Re: Pilgrim Station, Application for Amendment dated May 12, 1981

Proposed Change #81-102

License No. DPR-35
Docket No. 50-293

Revised Request for Technical Specification Changes
Concerning Single Loop Operation

FIGURE 1 CORE FLOW VERSUS DRIVE FLOW FOR ONE AND TWO PUMP OPERATION

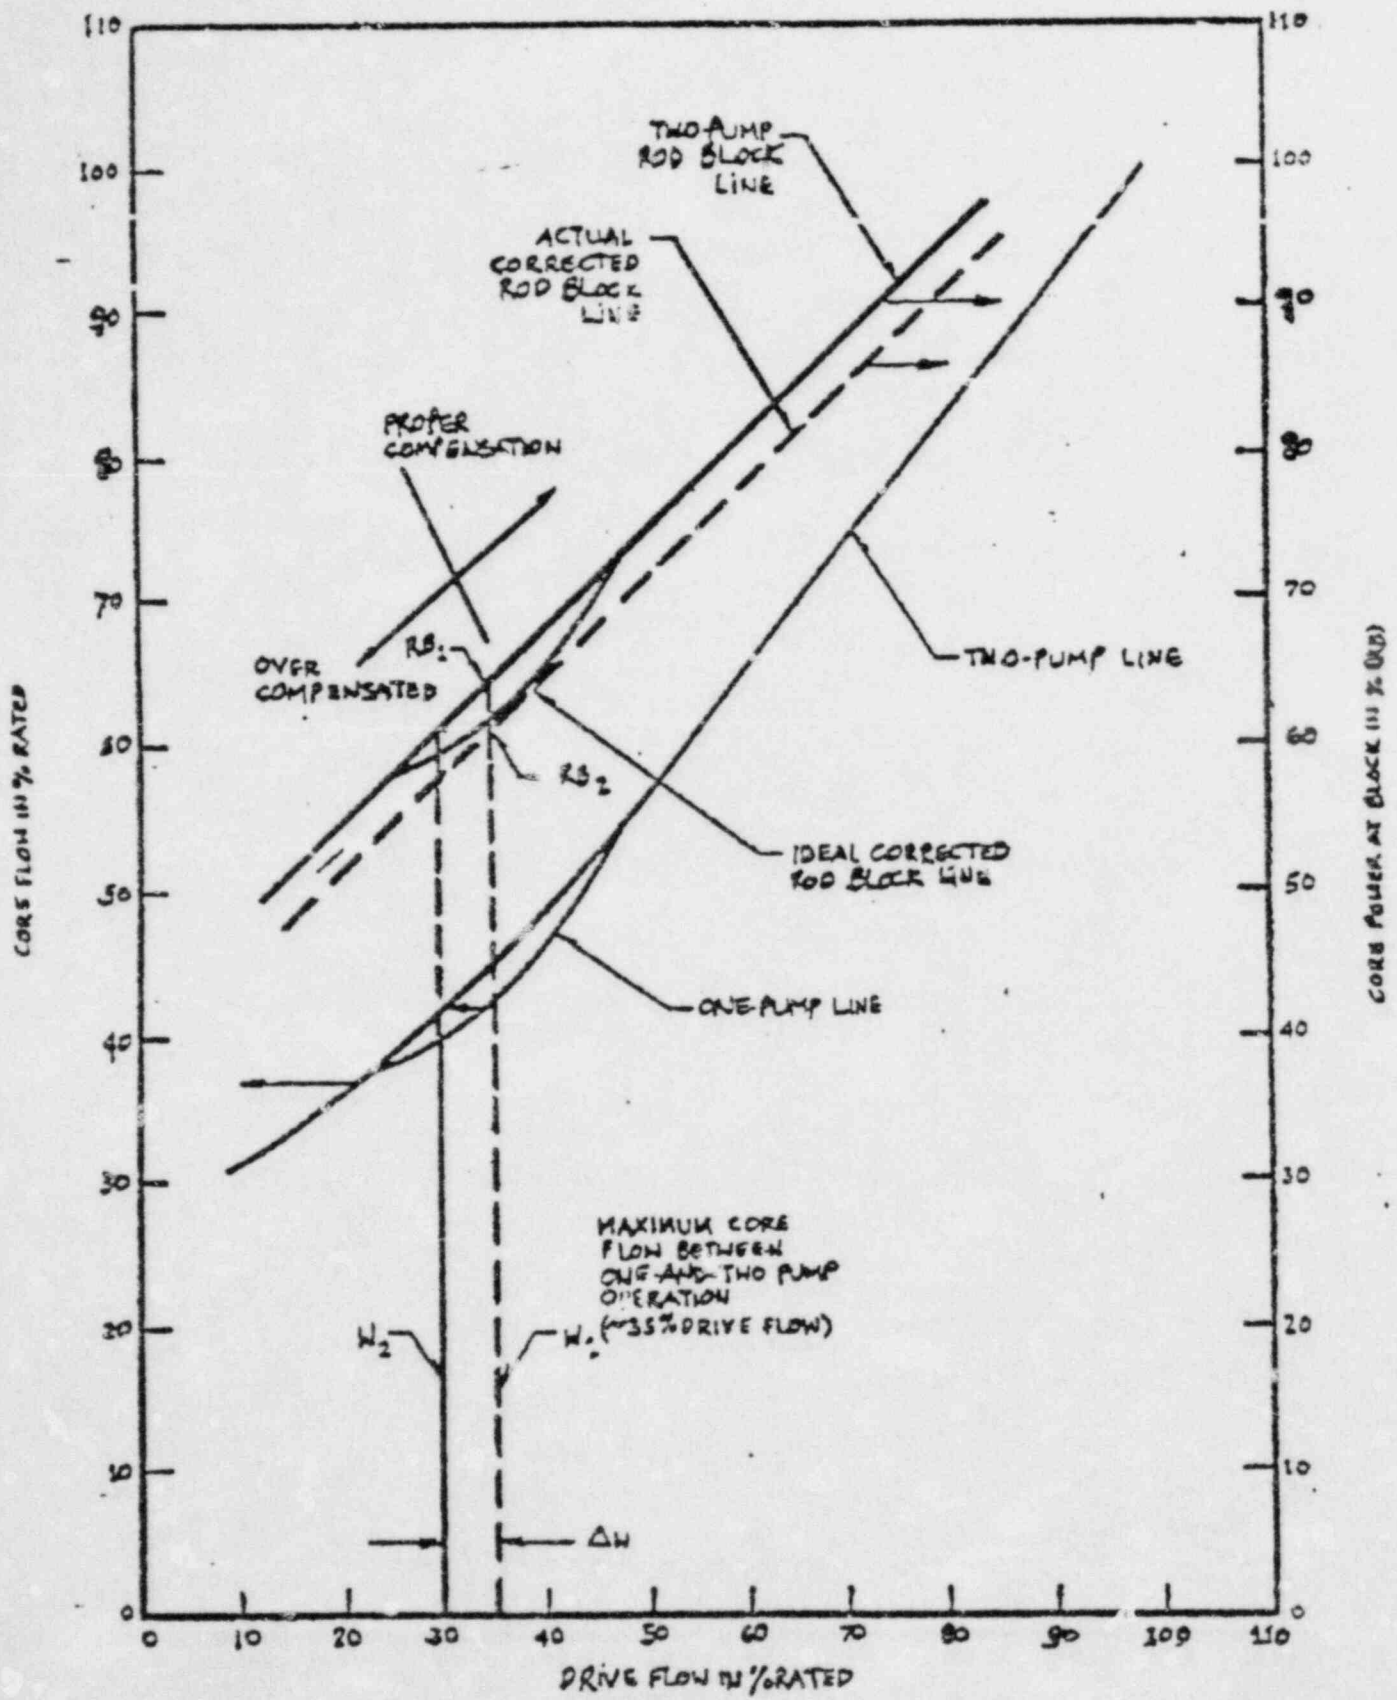
Both the active and inactive flows are derived from the jet pump differential pressures. The drive flow is derived from the differential pressure measurement in the active recirculation loop. These two curves are plotted in Figure 1. The maximum difference between the one-pump and two-pump core flow is determined graphically. This occurs at about 35% drive flow which is denoted W.

- c. Next, a horizontal line is drawn from the 35% drive flow point on the one pump curve to the two pump curve and the corresponding flow, W_2 , is determined. Thus, $\Delta W = W_1 - W_2$.

This line is depicted in Figure 1 as the corrected rod block line for one-pump operation.

$$RB = 0.65W + 107 - 0.65(100 + 5) = 0.65W + 38.7 \quad (4)$$

Figure 2.1.1

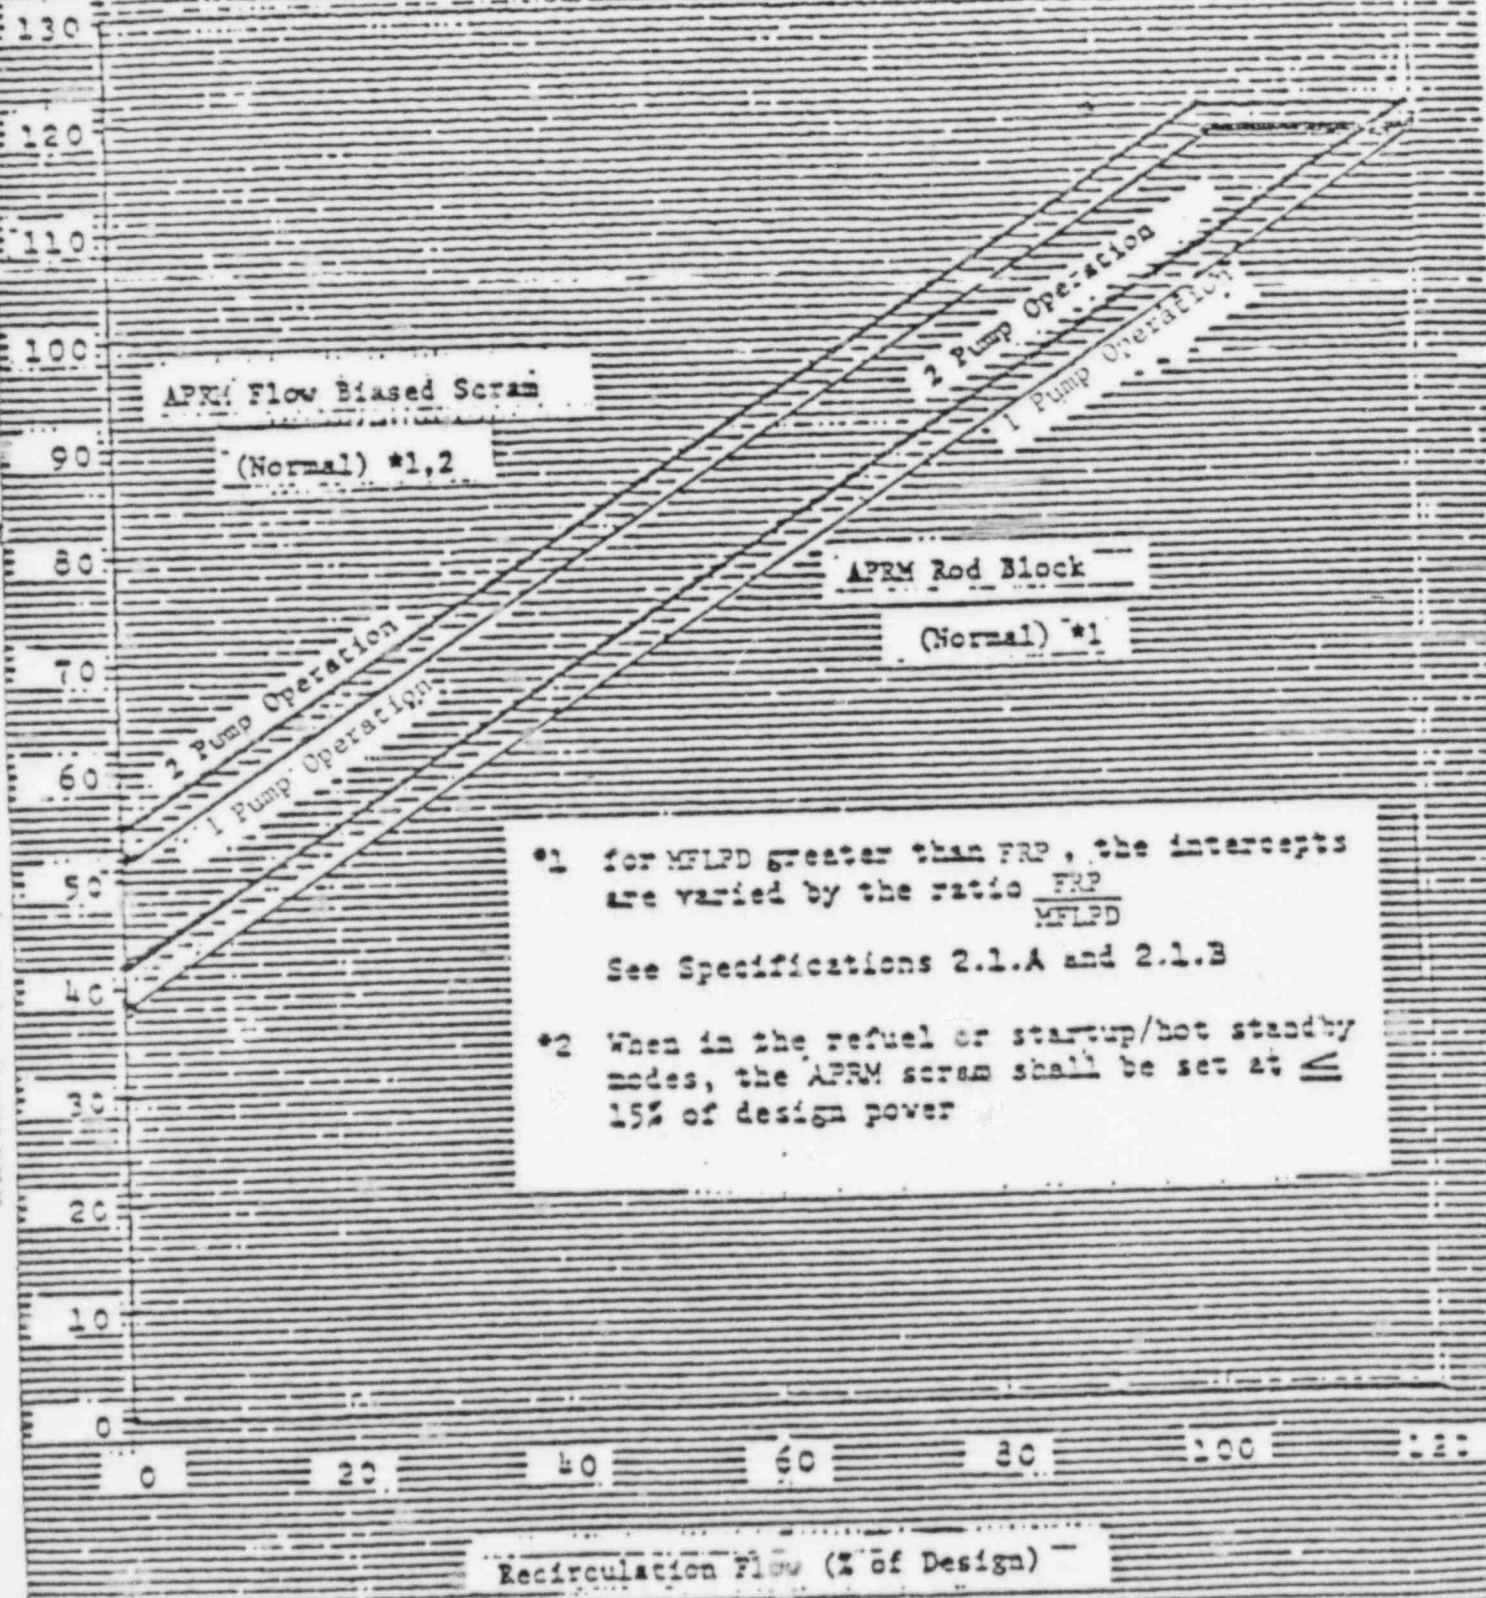
- *1 for MFLPD greater than FRD, the intercepts are varied by the ratio $\frac{FRD}{MFLPD}$
See Specifications 2.1.A and 2.1.B
- *2 When in the refuel or startup/hot standby states, the APRM scram shall be set at \leq 15% of design power

$$S_{RB} \leq 0.65W + 42\% \quad \underline{2 \text{ Loop}}$$

$$S_{RB} \leq 0.65W + 38.7\% \quad \underline{1 \text{ Loop}}$$

FIGURE 3.11-1

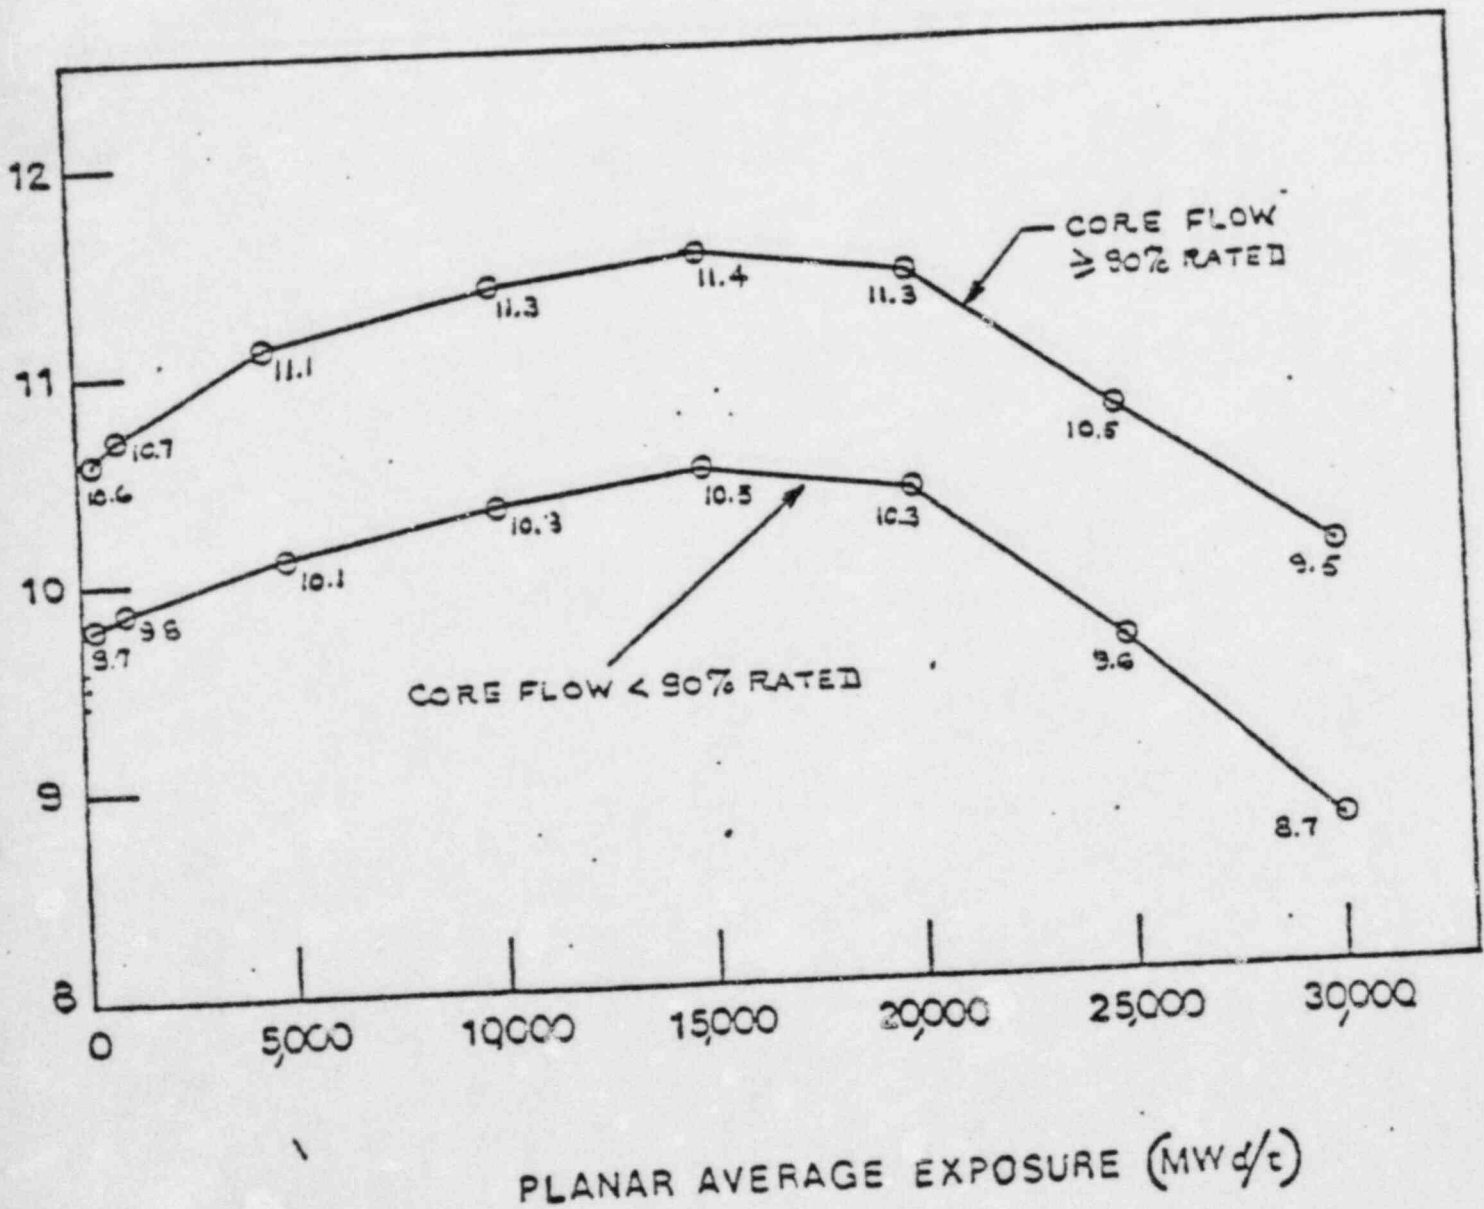
*For two recirculation loop
 Reduction factors for one recirculation loop were derived in
 "Pilgrim Single-Loop Operation", NEDO 24268, June 1980.

FIGURE 3.11-2
 MAXIMUM AVERAGE PLANAR LINEAR HEAT GENERATION RATE
 VERSUS
 PLANAR AVERAGE EXPOSURE
 FUEL TYPE 8DB219H

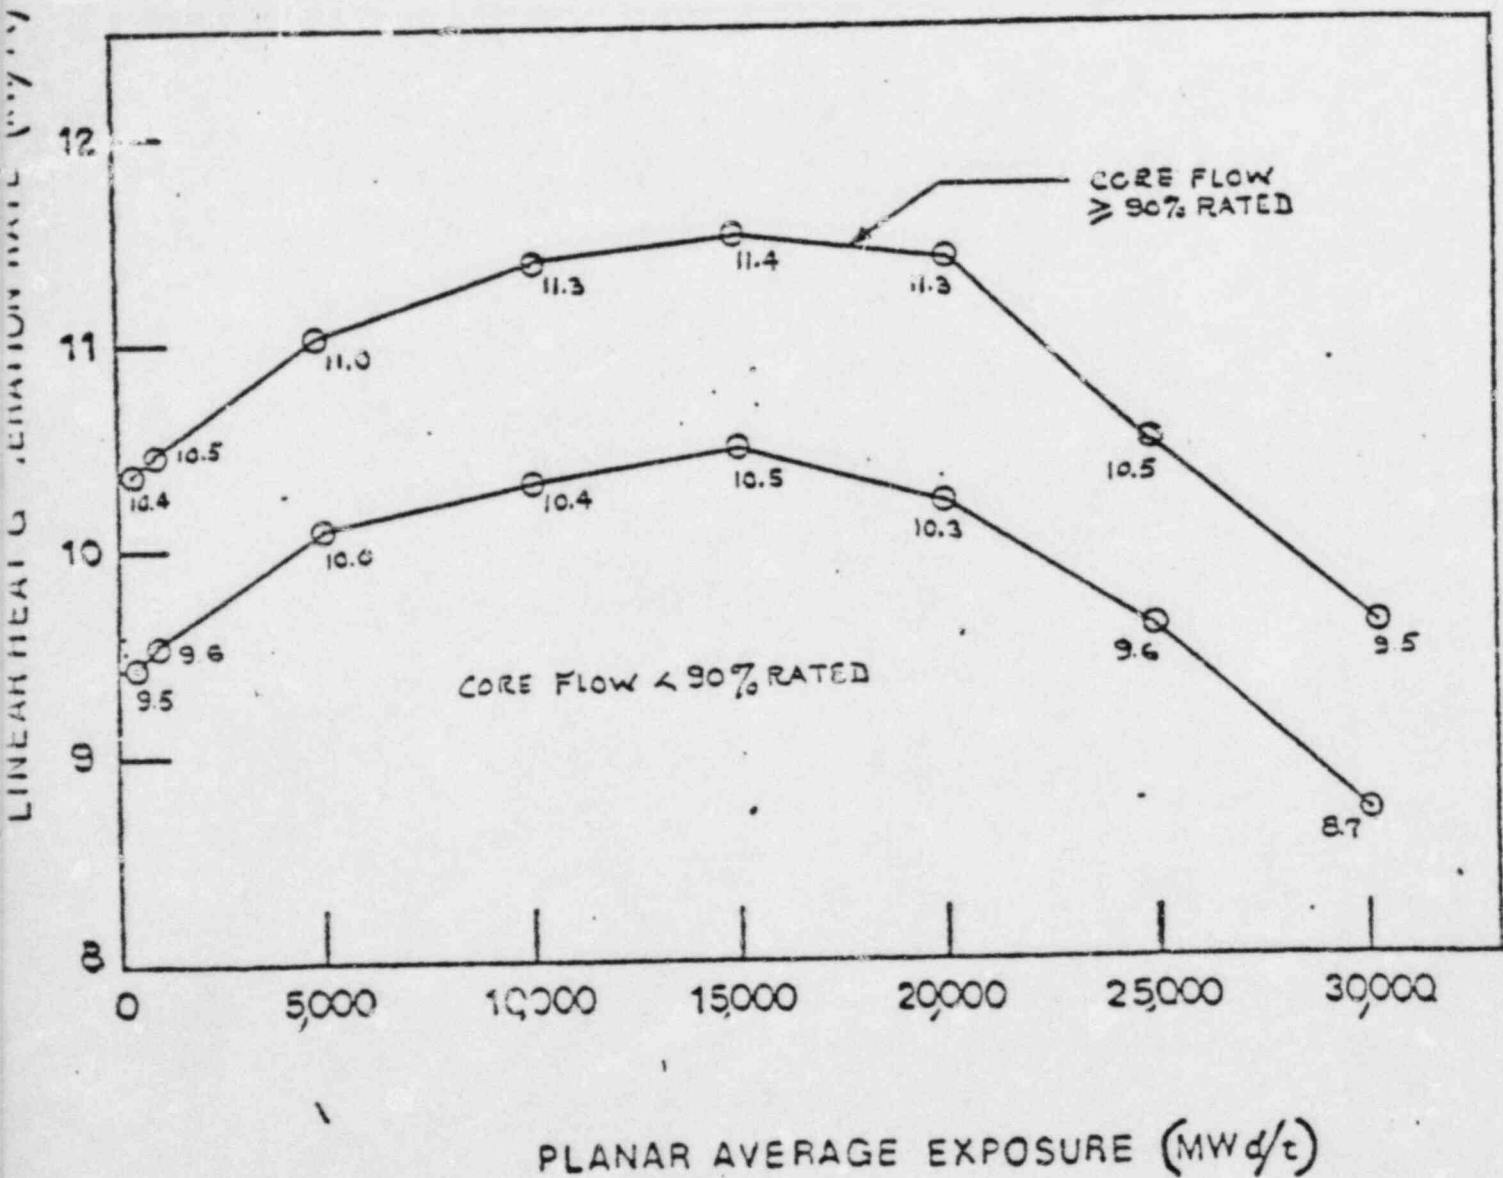
*For two recirculation loop
 Reduction factors for one recirculation loop were derived in
 "Pilgrim Single-Loop Operation", NEDO 24268, June 1980.

FIGURE 3.11-3

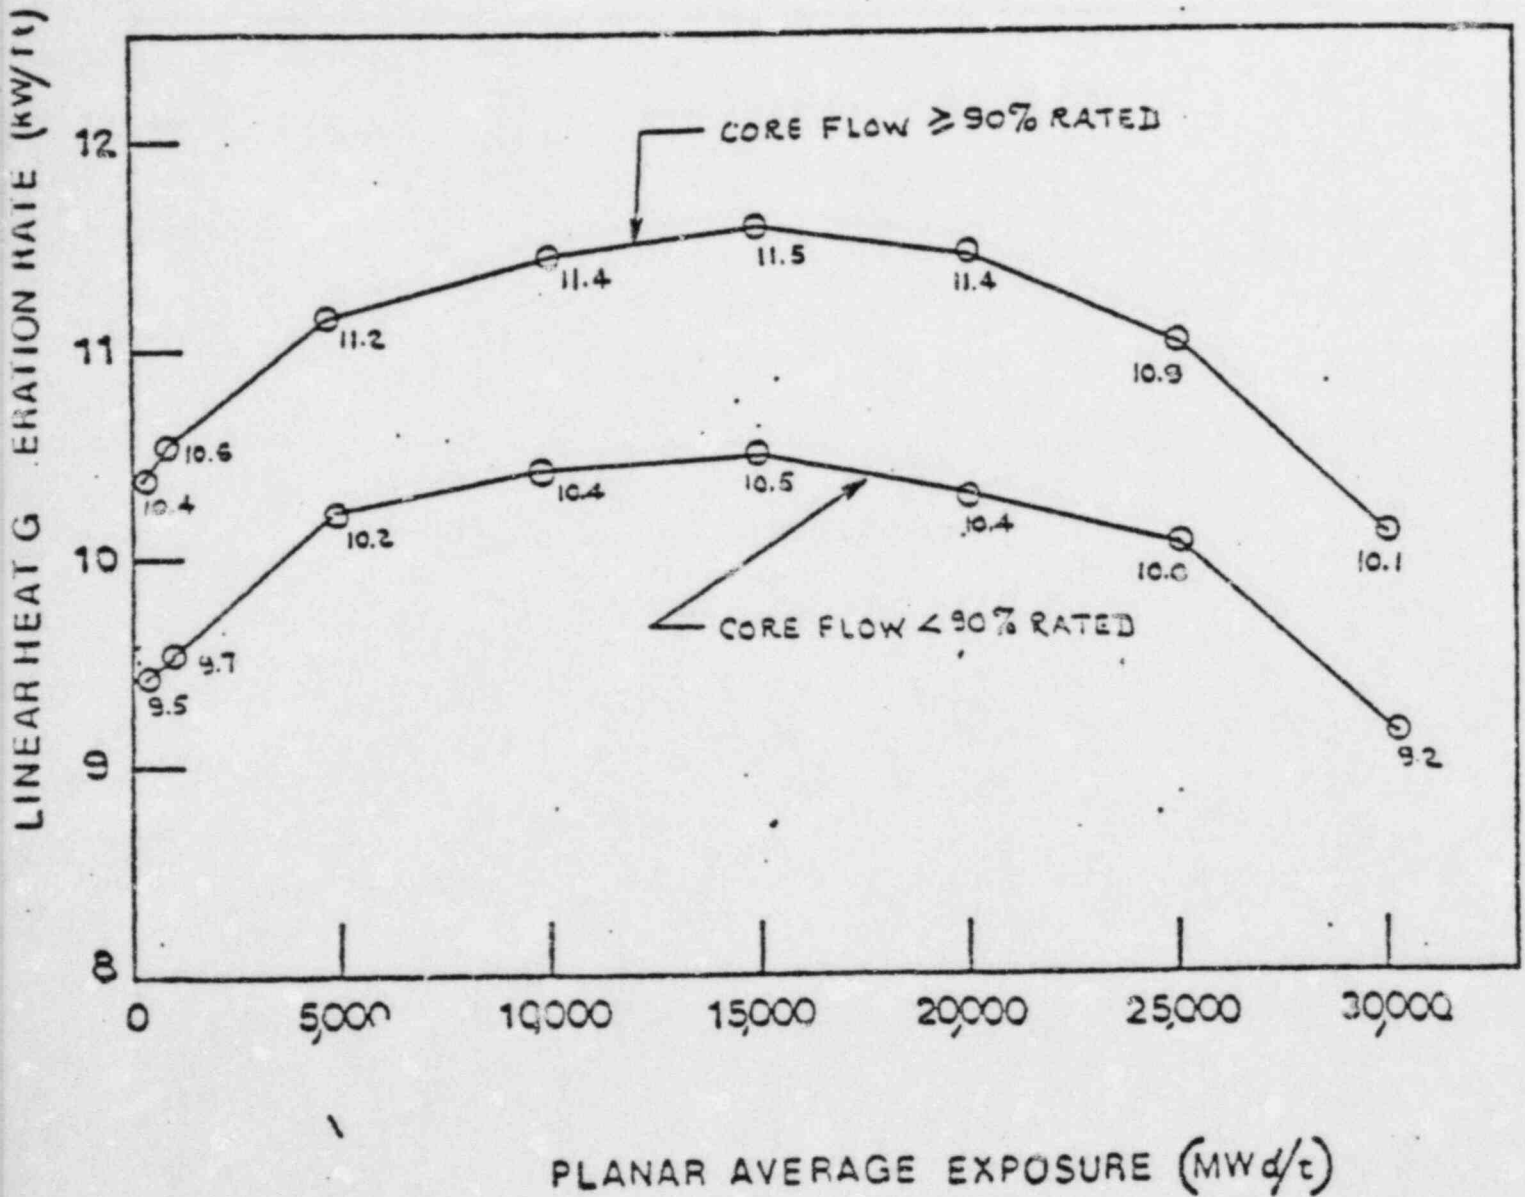
*For two recirculation loop
Reduction factors for one recirculation loop were derived in
"Pilgrim Single-Loop Operation", NEDO 24268, June 1980.
